## ADDENDUM NUMBER ONE

**RE-BID: USC UPSTATE LANDSCAPING FOR ATHLETICS  
PROJECT# CP00362341  
UNIVERSITY OF SOUTH CAROLINA UPSTATE  
SPARTANBURG, SOUTH CAROLINA**

**DATE OF ISSUE: FEBRUARY 14, 2013**

# TREE PLANTING DETAIL

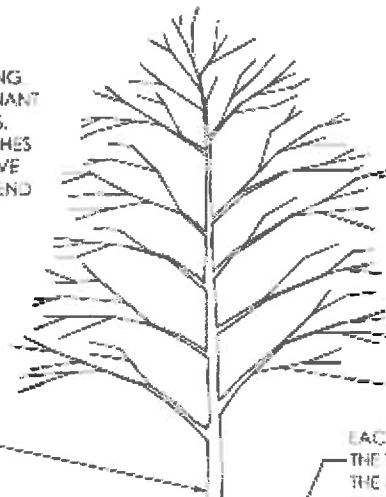
| 3. | See attached tree and shrub planting detail. (2 Pages)   |
